Draft SE for Topical Report of HFC-6000, Rev. A

Comments to Draft SE for HFC-6000 System

RR901-001-03-NP

Comments to Draft SE 2-15-11 for HFC-6000 System

16 **Figure 1 – Safety System Architecture Example Based on HFC-6000 Platform**
 17 **[Note: Only the components contained within the dashed-line box are within the**
 18 **scope of the topical report evaluation. Inter-channel communications has not**
 19 **been reviewed or approved.]**

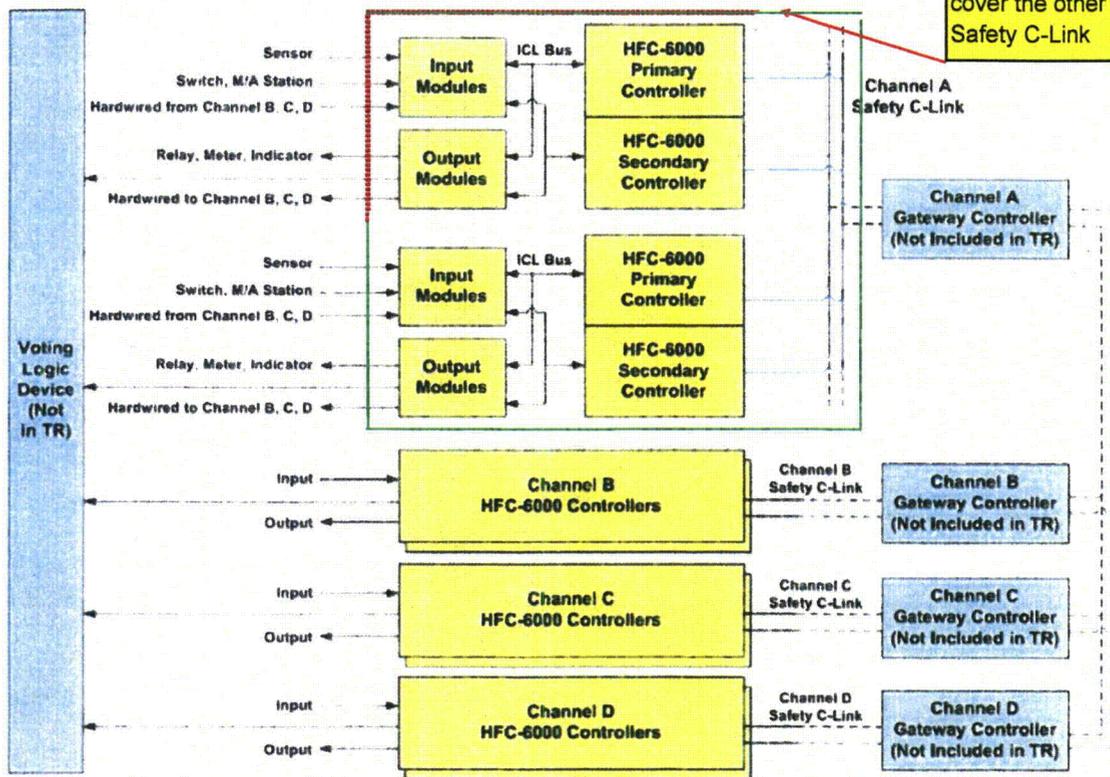
No.	Location	Suggested Change	Type of Change	Justifications
1	p.6 Figure 1	The red dashed-line box should extend to cover the other node and the safety C-Link in the figure. See comments in the document.	Content	Safety C-Link communication is part of the review scope. See reference 1 of the draft SE and RAI #122 response.
2	p.6 line 21	Remove "one node of"	Content	Same justification as in comment no. 1
3	p.7 lines 13-19	Remove "While the network interface for the HFC-6000 controller is an integral platform nodes, the fiber optic network medium, including the fiber optic transmitters that provide electrical-to-optical coupling, are not within the scope of the platform. Also, ". Line 16, make "the gateway" become "The gateway". Lines 18-19, remove "or other systems, either safety-related or nonsafety-related,".	Content	Same reason as change no. 1. Plus HFC-ILR06 is part of the review scope. See table 1 of the draft SE.
